CBM-Caledon Quarry

CAART COMMENT SUMMARY TABLE RESPONSE #1 – [VISUAL IMPACT]

Initial CAART Comments (March 2025)	Page / Section	Applicant Response (Oct. 30, 2025)	CAART Response (April 23 2026)	Applicant Response (May 28, 2026)	CAART Response (Date)	Applicant Response
Report: Comments on the Visual Impact Assessment prepared by Golder + Landscape Plans by MHBC			Author: J. Fedorowick, Wavefront Planning and Design Incorporated			
Methodology and Accuracy

Location of parking lots from which the northern quarry is visible.

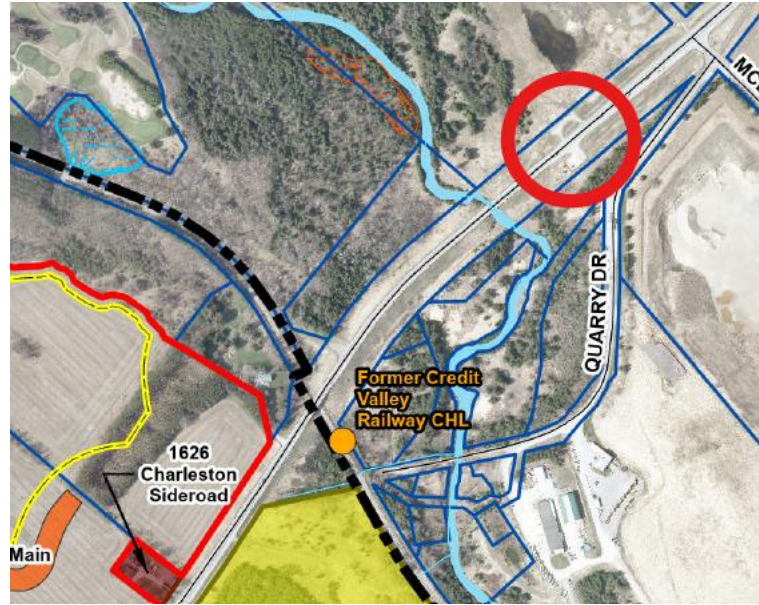
3.	Two viewpoints that offer panoramic and direct views of the extraction area were identified in the field but are not included in the VIA report.	VIA Peer Review Item 5.1, pg. 16	Viewpoints at public parking lots located on both sides of Charleston, northeast of the Credit River will not have a view of the Project. Adding an additional viewpoint at the south boundary of the North Extraction Area on Charleston Sideroad will not change the overall weak contrast rating for the effects assessment.	See attached location at the end of this document ... if you go out to the parking lots shown within the red circle, you can see the hedgerows in the Northern section. What type of mitigation would you propose for this panoramic view?	Upon careful review of the view from the noted parking lots (see image below), there is no need for a simulation from these locations as there is an extensive mature woodland between the parking lots and the quarry and the small cluster of trees that is to be removed within the Phase 2B limit of extraction is currently not visible from the parking lots.
